STAFF REPORT: MARCH 12, 2025 MEETING -- REVISED 03/24/25

APPLICATION NUMBER: HDC2025-00069

ADDRESS: 1090 VINEWOOD

SCOPE: ERECT ROOFTOP ADDITION/DORMERS

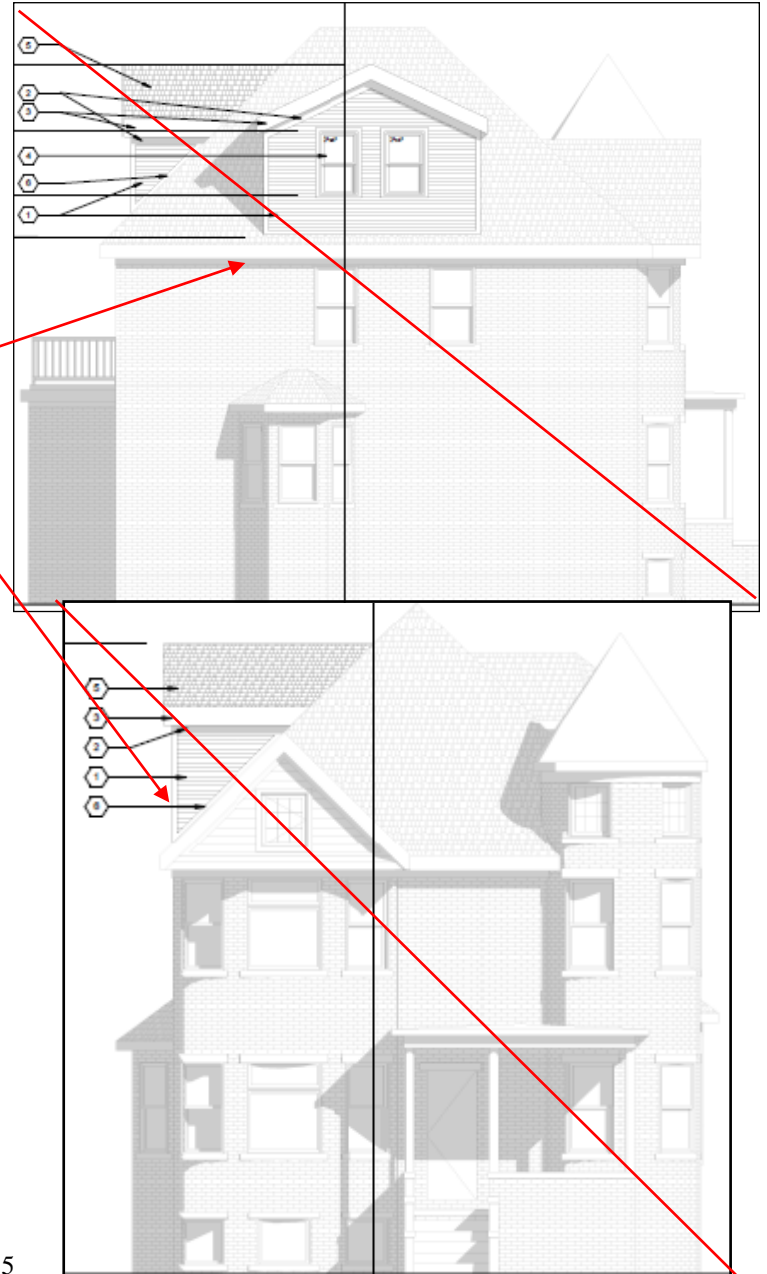
- ~~Staff finds some of the design features proposed for the north dormer to be incompatible with the house, specifically related to its placement, roof style and window openings—the dormer should be a secondary feature against the historic dwelling’s massing.~~

- ~~The north elevation drawing shows the front wall of the dormer set in slightly from the roof’s edge, but the façade’s elevation drawing shows this minimal setback aligns the dormer wall with the house’s north wall, making it look as if the dormer is a physical extension of the house.~~

- ~~Further recessing the dormer’s primary wall will allow the new construction to clearly read as a dormer, rather than as an extension of the house.~~

- ~~The two separate window openings should be combined into a single mullied unit, which is a common design feature for window openings on a historic building when there are multiple windows within a small wall surface. A factory mullied double window would be a contemporary, compatible option.~~

- Using a hip roof (rather than the suggested gable) would echo the angular profile of the house's hip roof and match the profile of the southern roof line of the historic dormer. This would reduce the visual impact of the dormer while allowing the applicant to retain the majority of the requested interior vertical space.

- ~~The north dormer will be recessed a minimum of an additional 12 inches from the wall of the historic house, and the roof design for the north dormer will be changed from gable to hip.~~
- ~~Aluminum clad wood double hung, one over one windows will be selected, and the window openings will be modified to become a centrally placed and factory mulled, two window opening.~~
- ~~Wood lap siding will be used on the walls of both dormers. Dimensions confirming the exposure and siding profile will be submitted for staff review.~~
- ~~The scope of work, drawings and cut sheets will be revised and submitted to staff for review.~~

Applicant drawing -- Building section, looking through the dwelling from south to north. The east/rear wall is at the right side of the drawing; the dark thick lines illustrate the proposed roof and wall placement for the rear dormer.

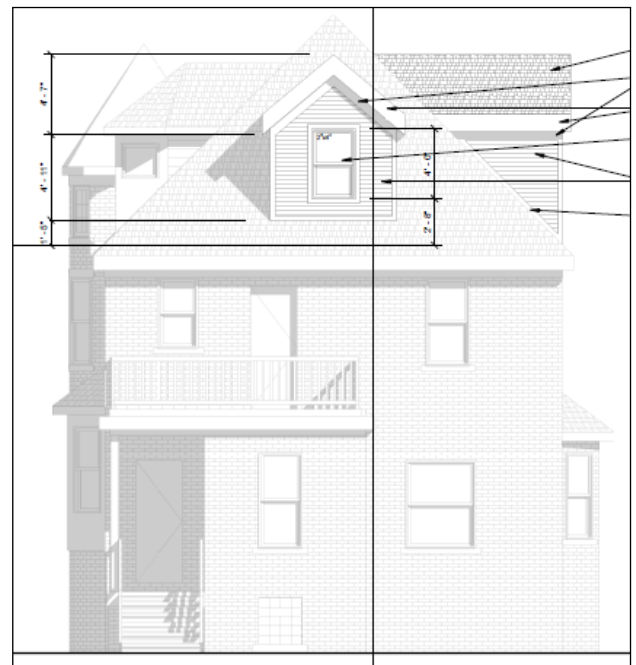
- Staff does not have ~~similar~~ concerns with the placement and roof design for the rear/east elevation dormer. The recessed location of the dormer falls akigns with staff's previous recommendations for appropriate design and placement of dormers, and the gable roof with matching pitch of the historic hip roof doesn't compete against, but rather mimics, the existing roof shape and building massing at this rear location.

Applicant drawing -- Rear elevation. The placement of the dormer is proportional to the surface area of the roof. The dominant view of this dormer will be from the rear, therefore the primary profile of the dormer's gable roof matches that of the hip roof (in contrast to the dominant side view of the north dormer).
